Product Change Notice (PCN)

PCN Number: PCN-0334014R-01

Product(s) Affected: CMR-2747PB-A

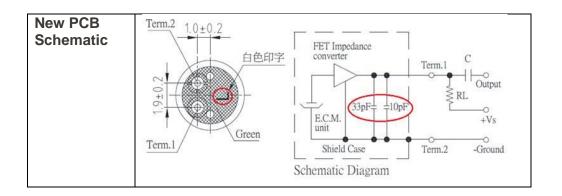
Reason(s) for Change: PCB update.

Description of Change: PCB changed and capacitors 10PF & 33PF added for anti-interference.
